Ref No.: BD-ACEPM-SAMCO-LET-022

Project Name: The Big Business District

Contract/Package: Construction Works of the Civil Works for Buildings B1, B2, B3 and B4

Subject: Re: Design Review

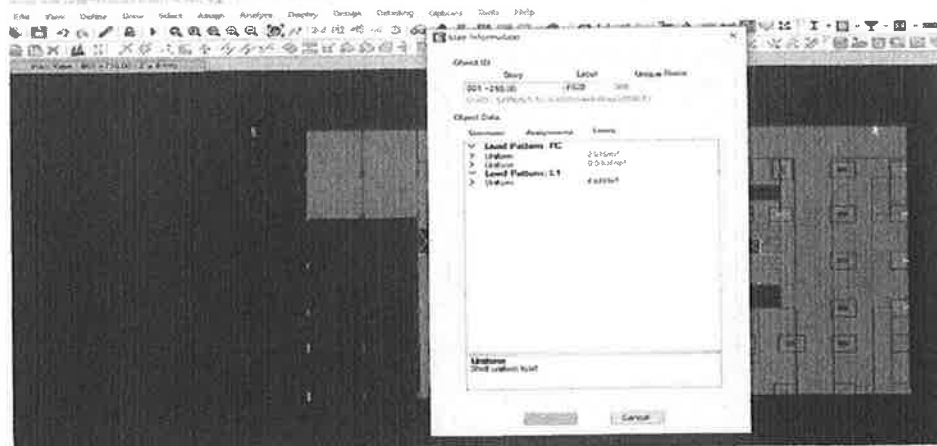
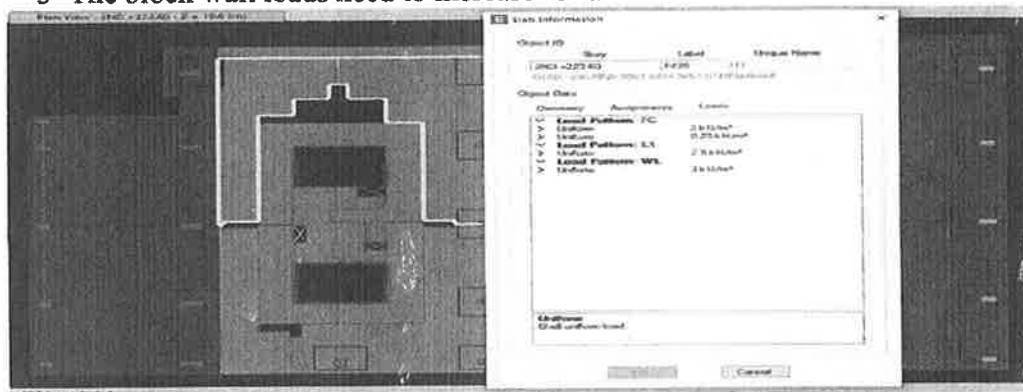
- The plaster loads is missing for Basement slabs.

- The pavement loads need to increase.

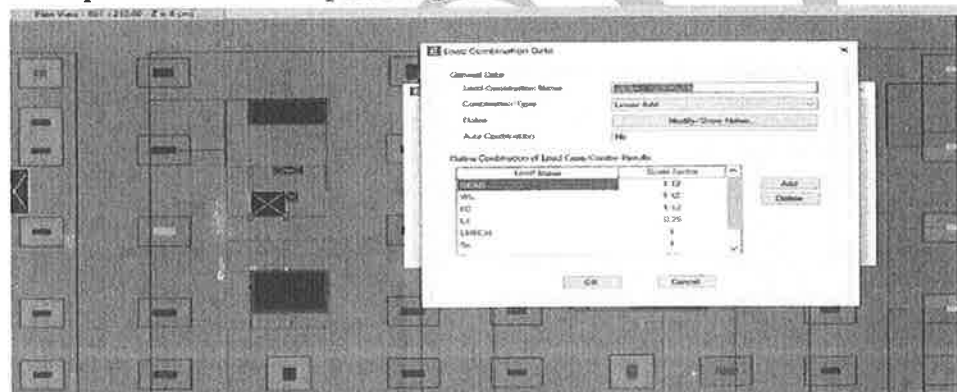
6- As per ECOP-201, Clause 2-1-2-1, the live load should be included only once in the load combination (LL).

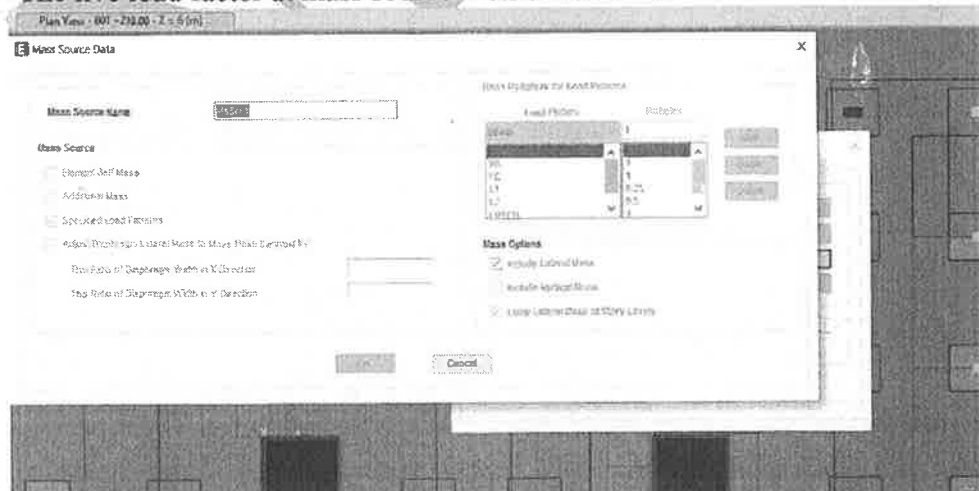
7- The equivalent Live load percentage = 50% instead of 25 %

8- The live load factor at mass source = 0.50 instead of 0.25

Seismic loads based on the current live load% and importance factor of 1.0 are complied with the Egyptian code requirements.

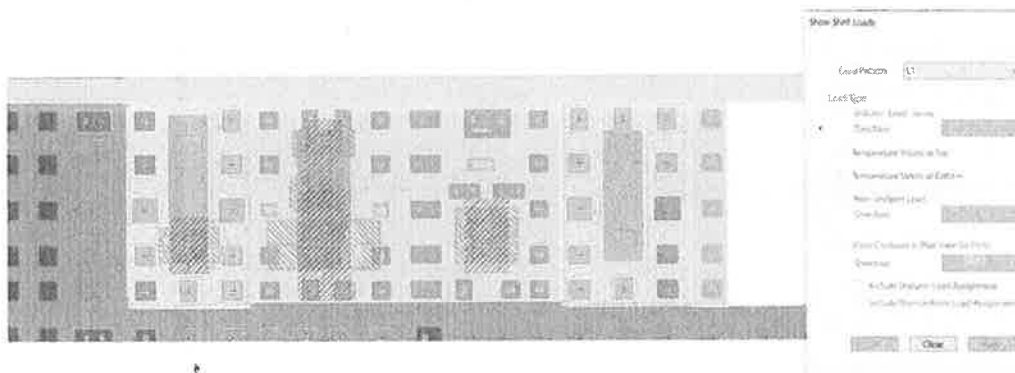
1- The live loads is missing.

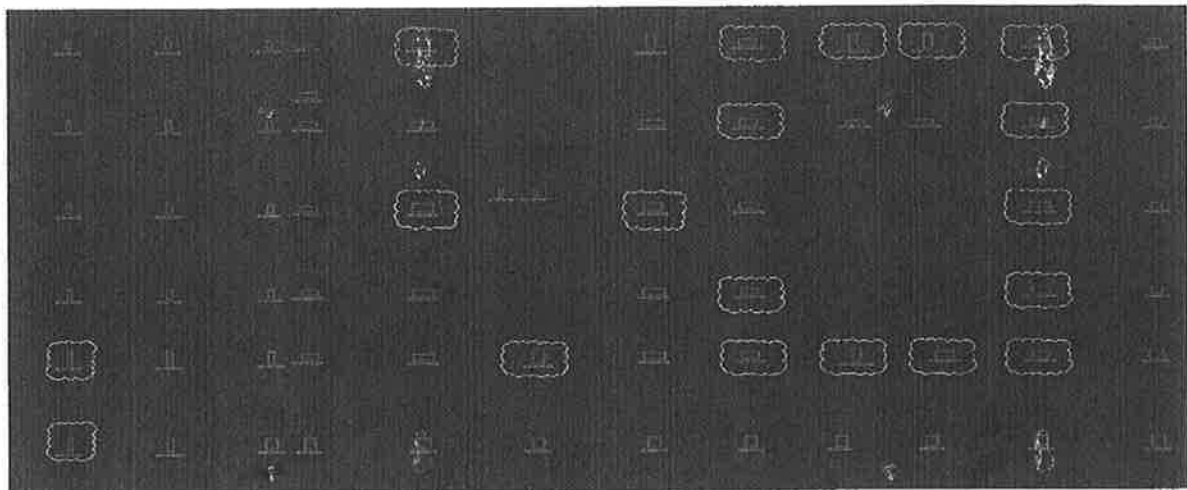
2- The foundation should be designed considering the seismic loads from the ETABS model, after modifying the response reduction factor (R) to 3, in accordance with ECOP-201, Clause 8-8-2-6

Plan View - B01 - 210.00 - Z = 6 (m) Column P-M-M Interaction Rabos (BS 8110-97)

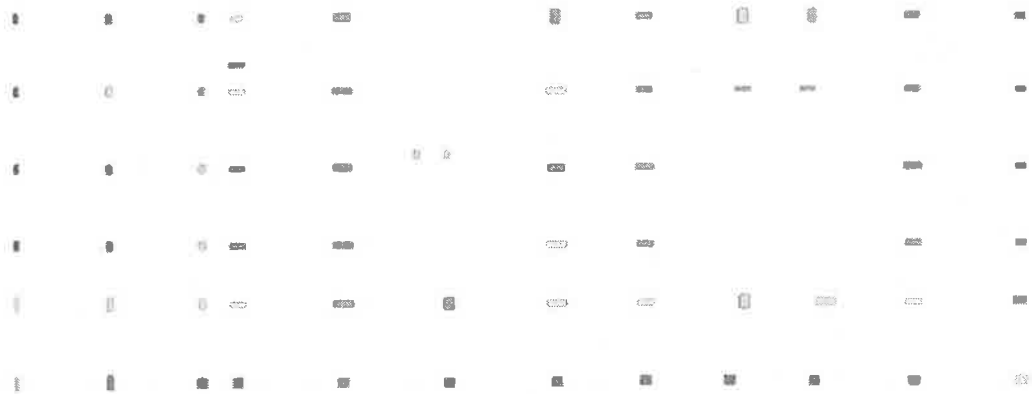
The columns sections and reinforcement in the model bigger than the drawings for the clouded 19 columns .

The mentioned columns columns are consider unsafe + the above columns.

Wall – B01-W2

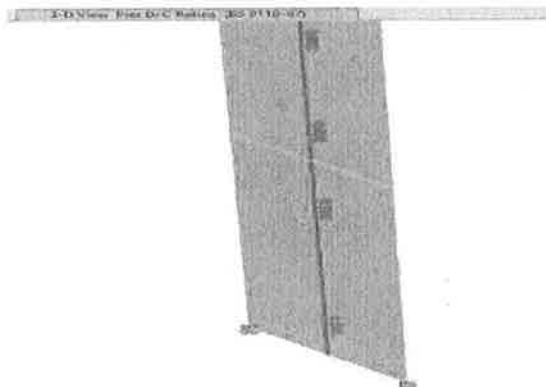
4 walls sections are consider unsafe.
